Department of Energy

DOE-0018-07

CORRECTION OF CERTIFICATION AREA BOUNDARY BETWEEN AREA 2, PHASE III - PART TWO AND PADDYS RUN

ATTACHMENT 2.

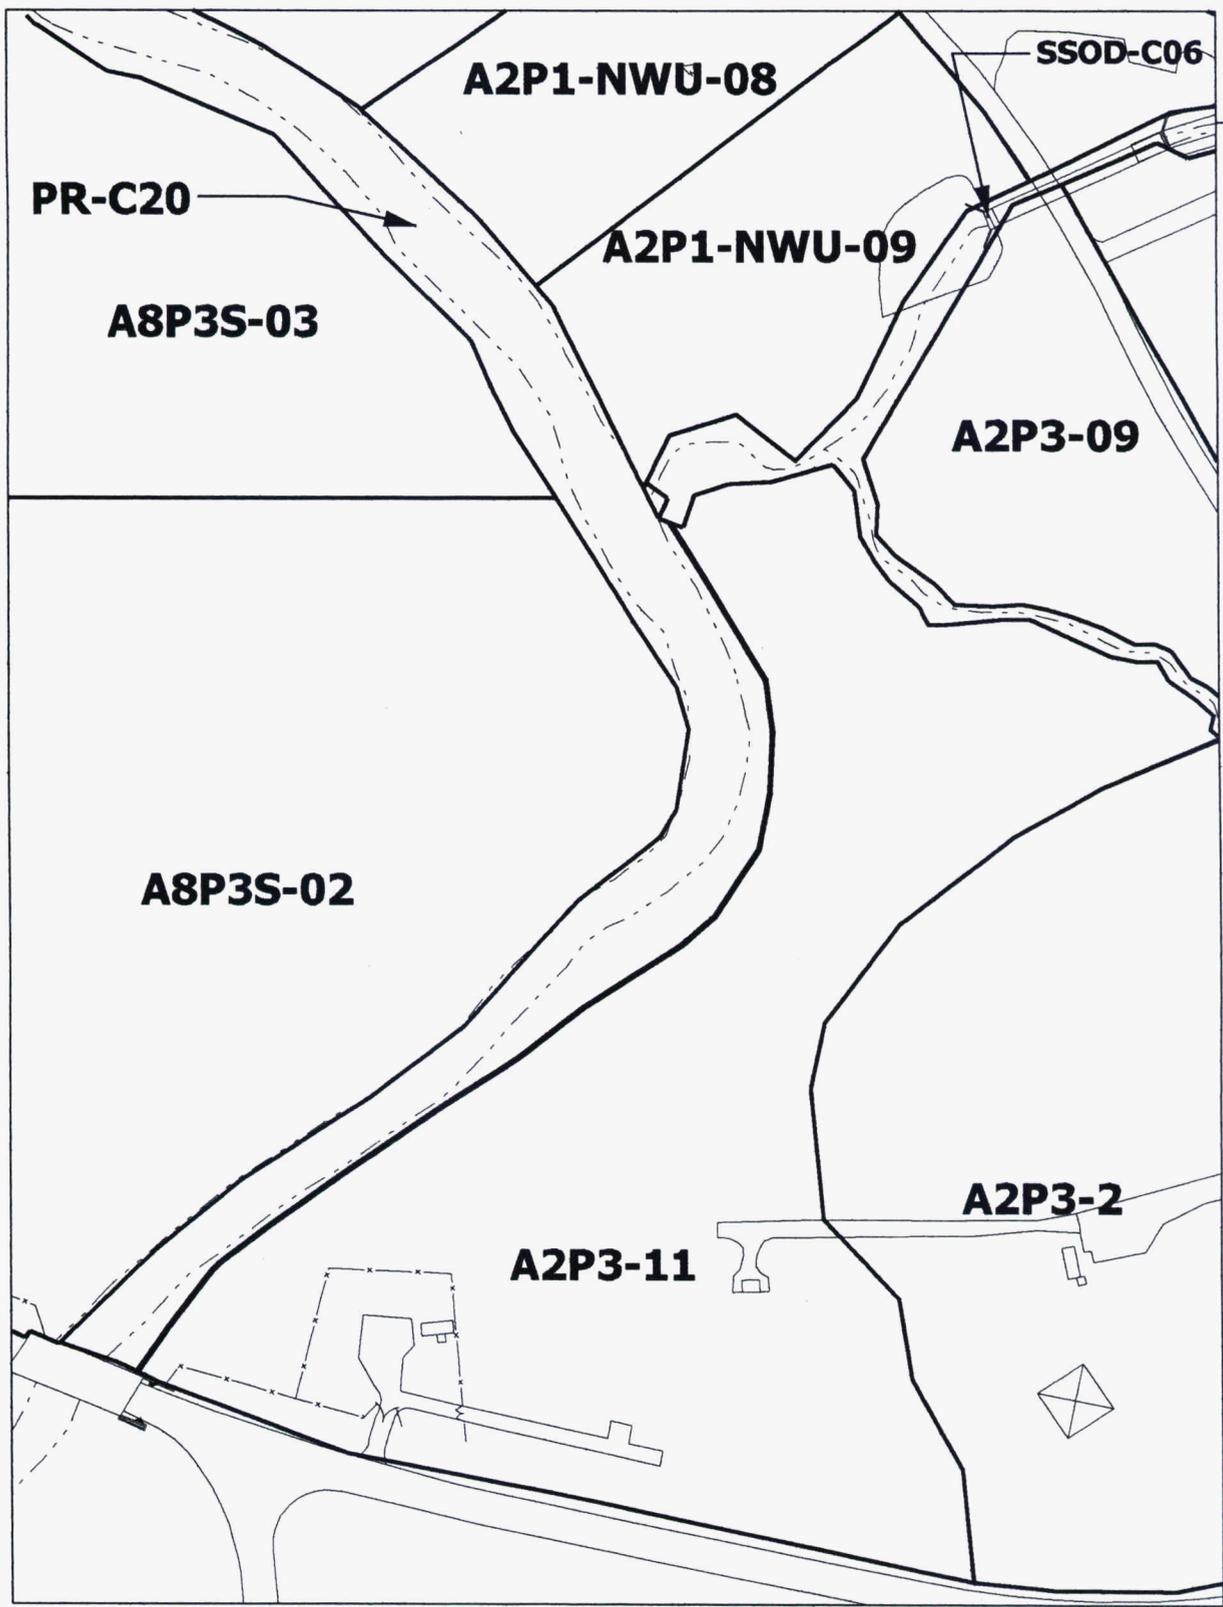
The purpose of this letter is to document a minor correction of the boundary between two certified areas: Area 2, Phase III (A2PIII) - Part Two and Paddys Run south of the Storm Sewer Outfall Ditch (SSOD) as established in the Fernald Closure Project Controlled Certification Map. A gap (see Attachment 1) was noticed in the electronic file when a larger scale of the map showing all the individual certification units was reviewed to ensure full coverage of the site that is required to complete the Geographic Information System (GIS) database in the residual risk assessment tool being developed. This gap is not visible on the hard copies of the map normally produced for certification reports due to its small size.

The gap in question is a woody area along the top of the eastern bank of Paddys Run from Willey Road to the SSOD. A field walkdown was conducted this past summer to confirm that the area does not require any remediation or further characterization. The area has actually been real-time scanned previously during the A2PIII precertification without anomaly being found.

Based on all the available information in this area and certification data from the adjacent certified areas, it is determined that this small gap can be incorporated into the adjacent certified areas. Therefore, the boundaries of the two areas have been adjusted to match along the centerline or middle point of the identified gap (see Attachment 2).

REVISED PADDYS RUN/
 A2PIII BOUNDARY
